AGENDA ITEM: 5.3

Proposal: Two Storey Residential Flat Building comprising Three Dwellings, Front Fence and Removal of Significant Tree (DA 050/103/2017)

Address: 78 Harvey Street, Collinswood (CT 6163/893)

Recommendation: Refusal

SITE PLAN

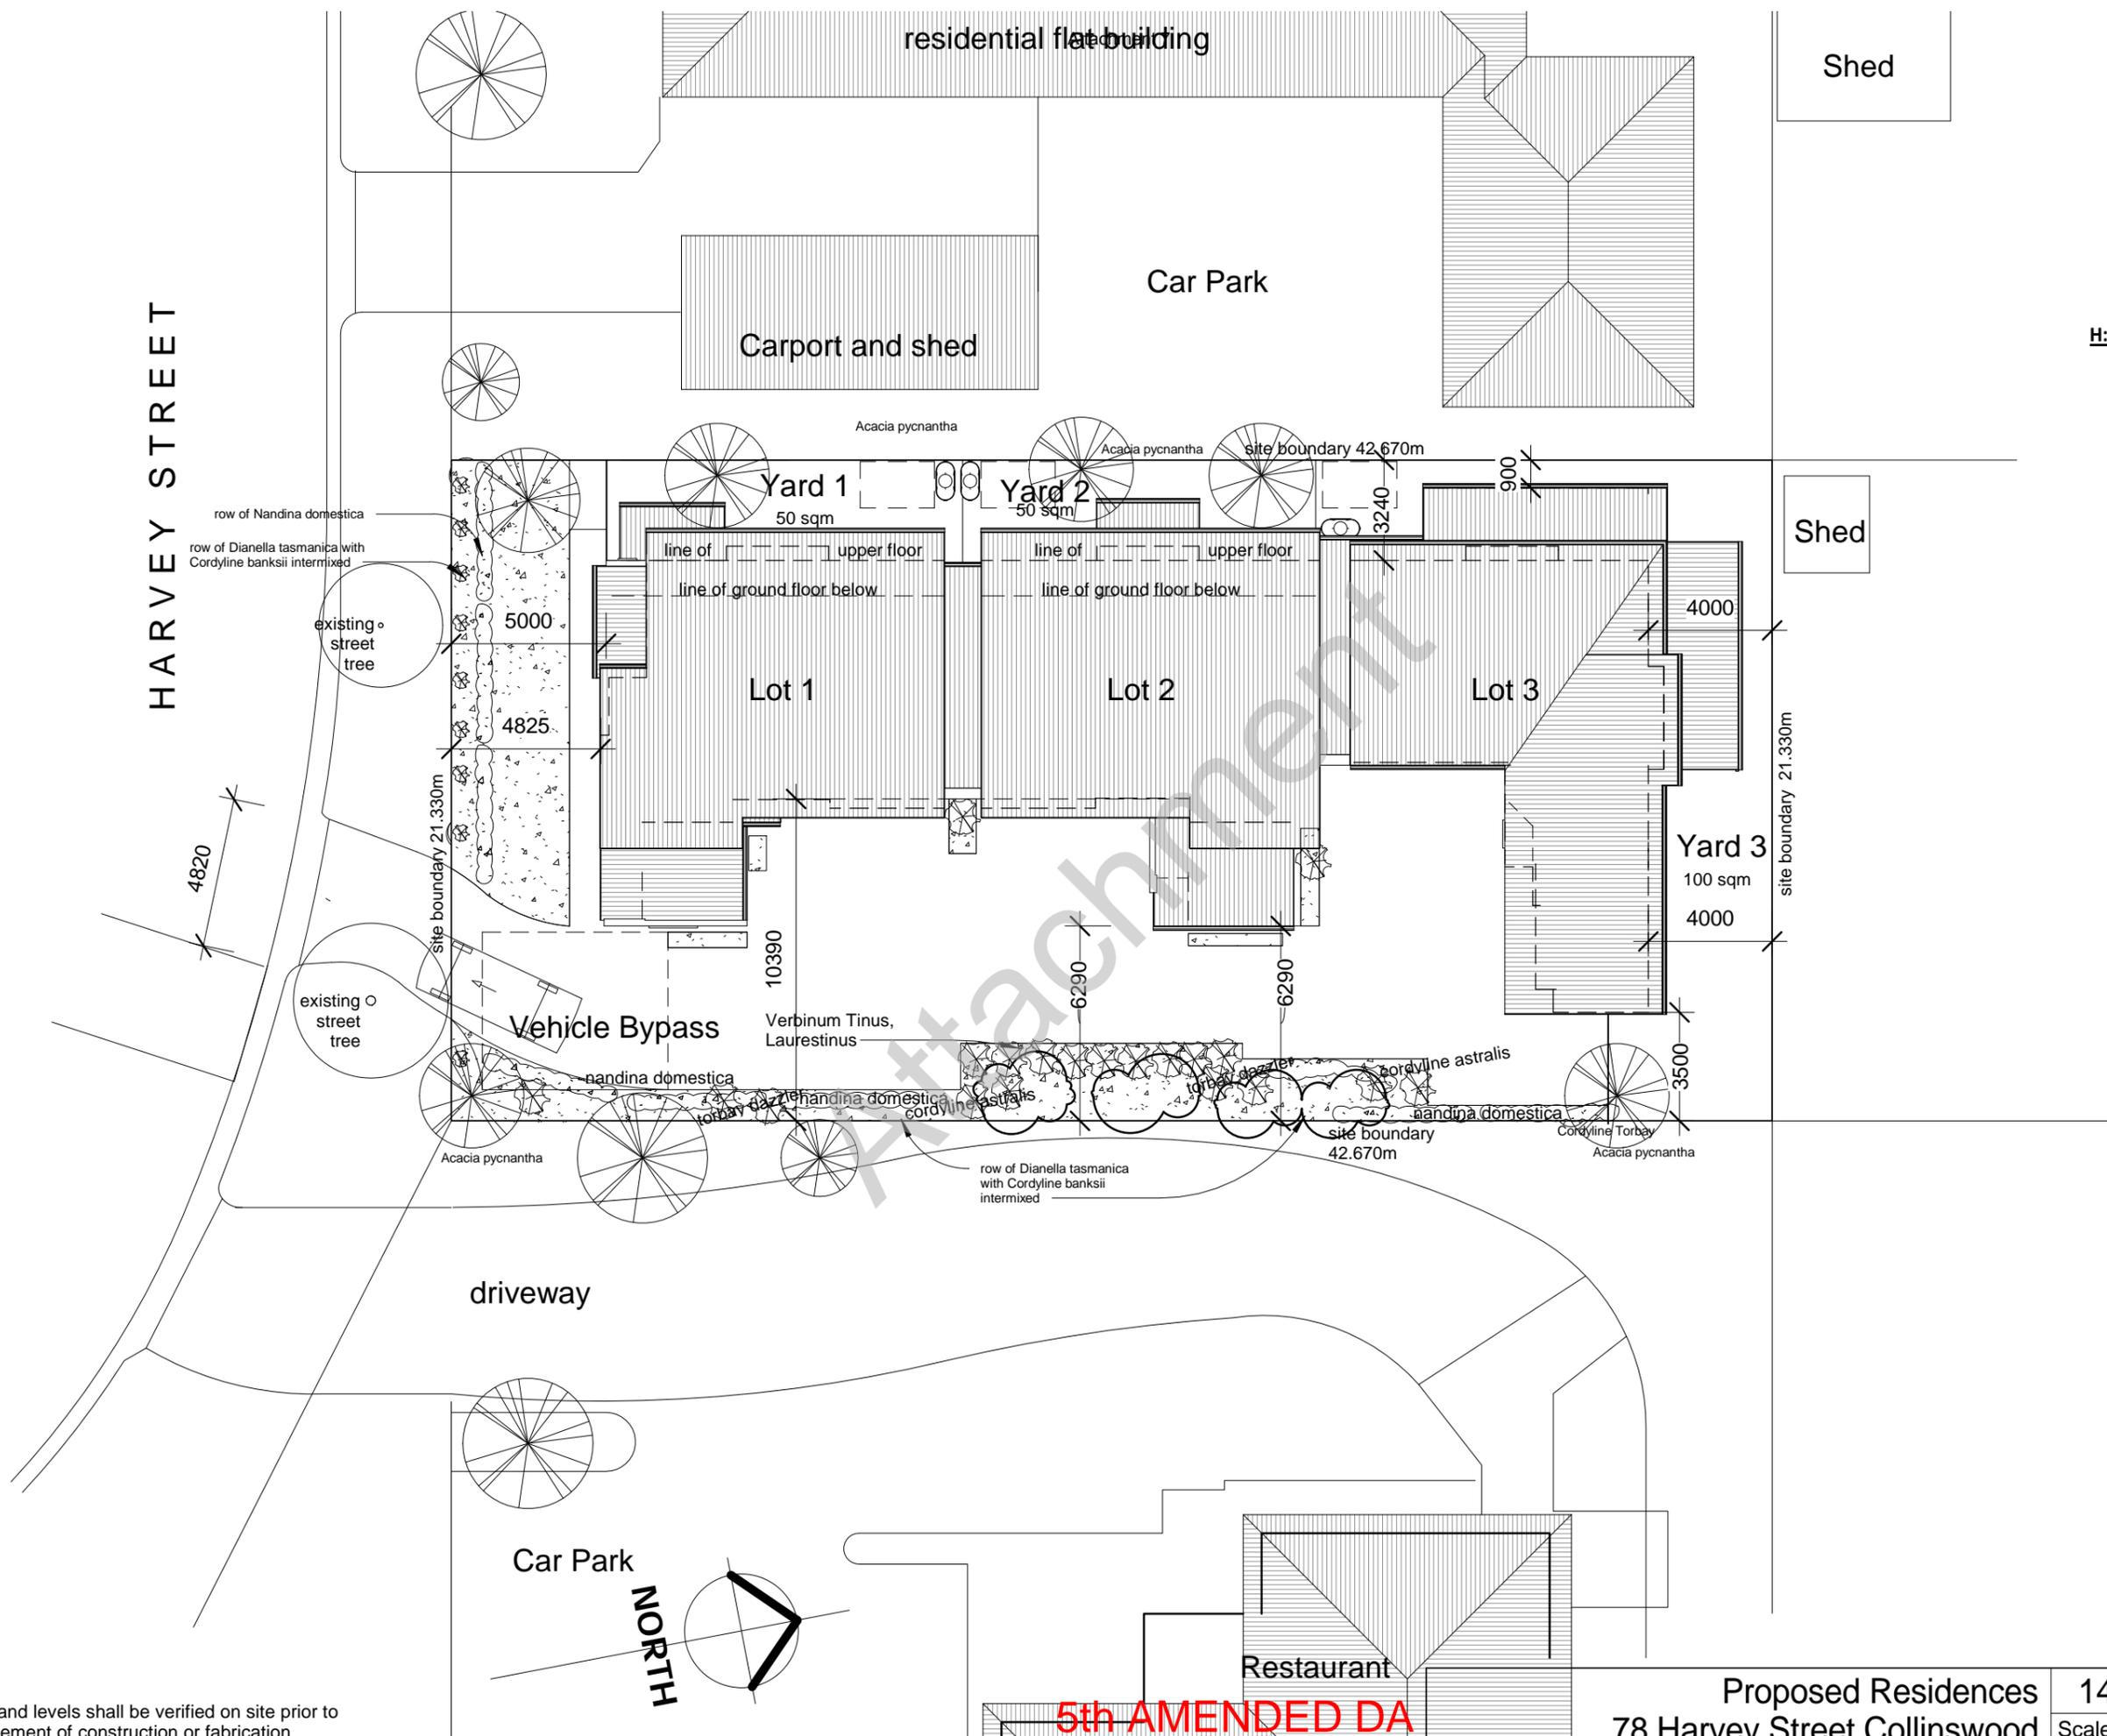
7.13.2 The applicant has provided landscaping details as described on the site plan, which comprises of low lying shrubs to the front of the site and within the common driveway (refer **Attachment 7**).

7.13.3 Replacement plants are proposed adjacent the eastern boundary, to replace the significant tree. The replacement plantings would comprise of a combination of dense shrubs and ground cover. The applicant proposes to plant several Syzygium Paniculata "Backyard Bliss, which are a dense shrub that is fast growing.

7.13.4 The existing tree is approximately 16-18 metres in height. The proposed plantings would range in heights of up to 2m (for the ground cover-low lying shrubs) and the Syzygium Paniculata "Backyard Bliss has an approximate mature height of 3-4m.

7.13.5 While the plantings would be fast growing and would provide a dense screen along the eastern boundary, it is noted that the window sill height for the east facing windows on the upper floor would be approximately 4.5m above the ground level. Thus, while the plantings would provide reasonable screening to the ground floor and common driveway, it is noted that the proposed plantings would not provide an adequate visual or acoustic buffer between the upper level of the proposed dwellings and the McDonalds drive-through.

7.13.6 In this regard, the proposed landscaping is not considered to provide an appropriate level of softening to the appearance of the proposed dwellings as viewed from adjoining properties, or more fundamentally, provide reasonable level of screening in lieu of the removal of the significant tree.

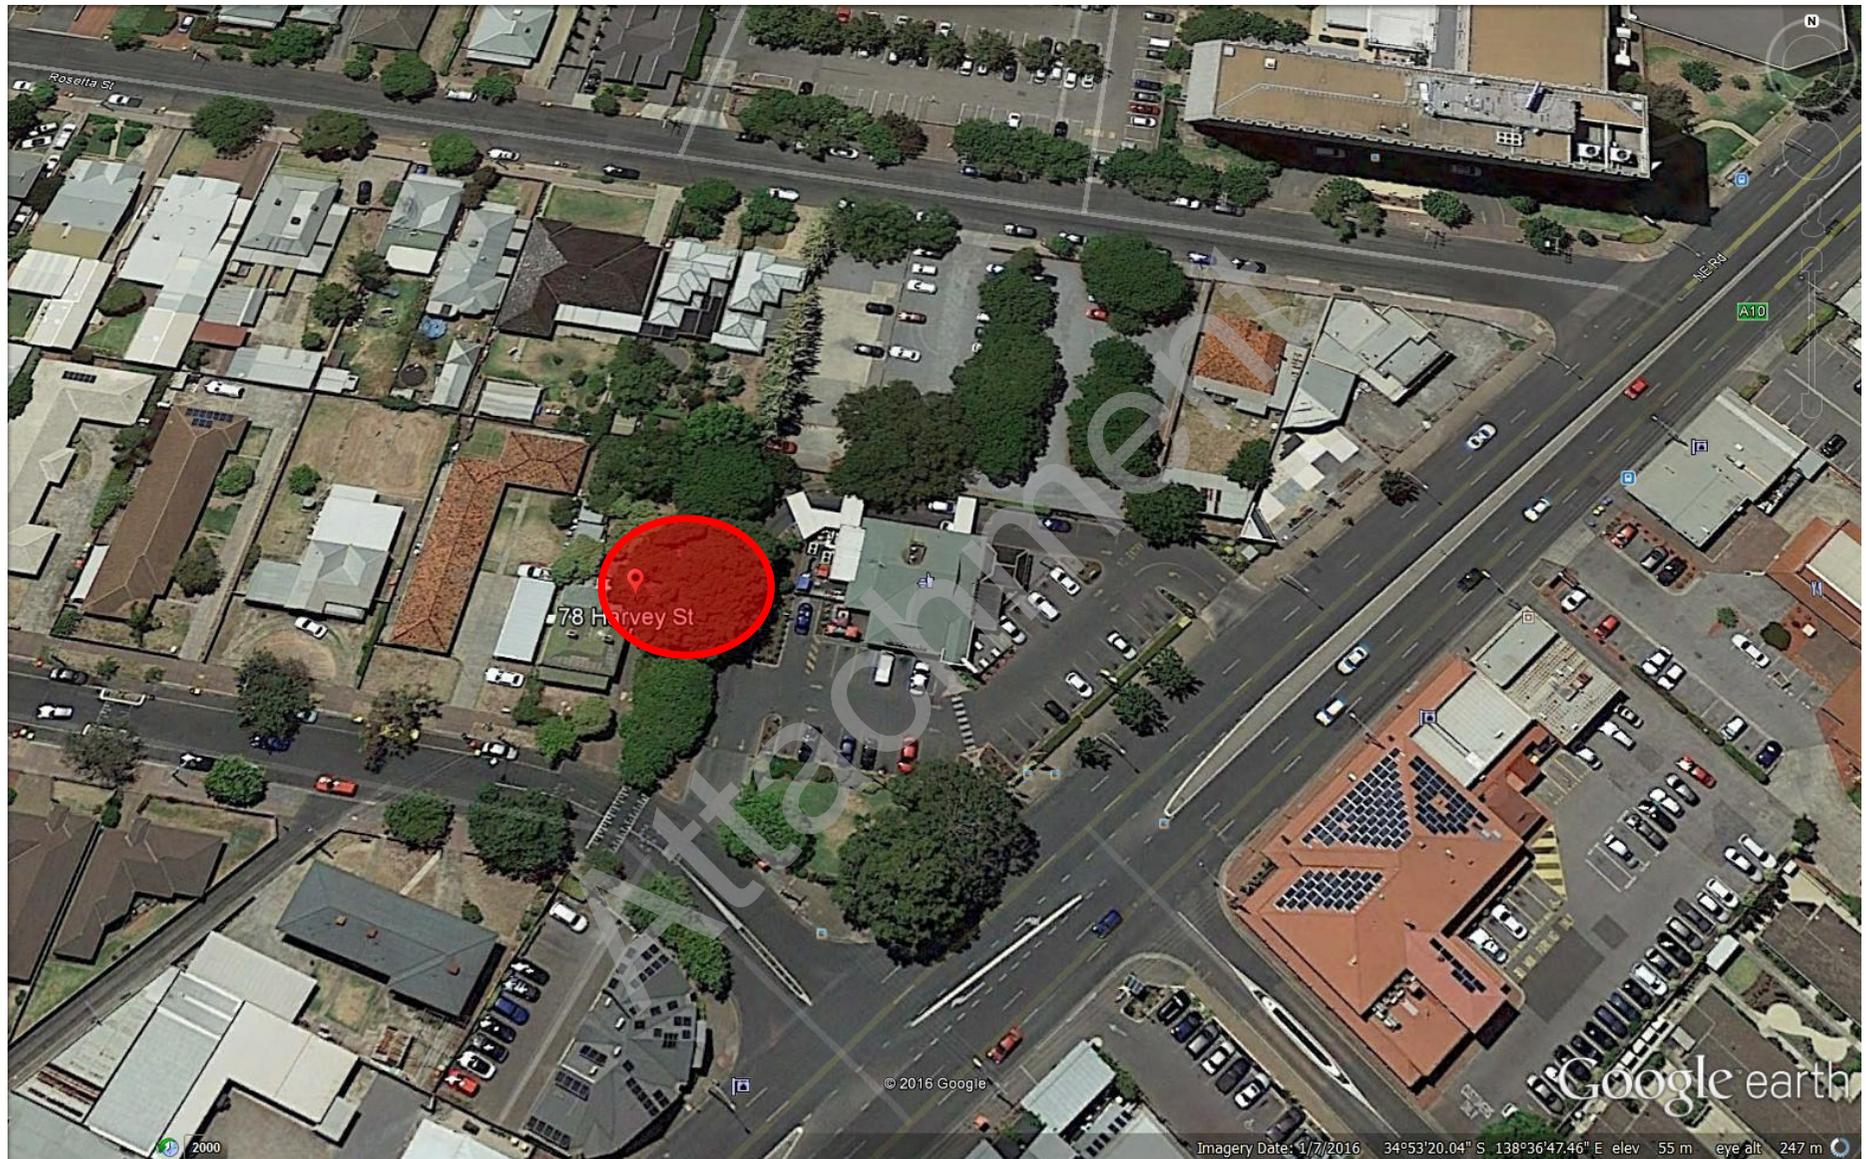
The canopy of this tree dominant's the subject land. The level the canopy this tree encompasses of the subject land can be seen on the aerial image listed in Appendix A. The canopy of the subject tree is broad with the extremities of the western crown supported by existing structures (refer Figure 6).

All trees pose some degree of risk which increases with age and sometimes through modified site conditions and or environmental stress. I suggest the risks associated with branch failure/s, for the foreseeable future for the subject tree is considered low to moderate. The tree has already experienced 4 branches to date.
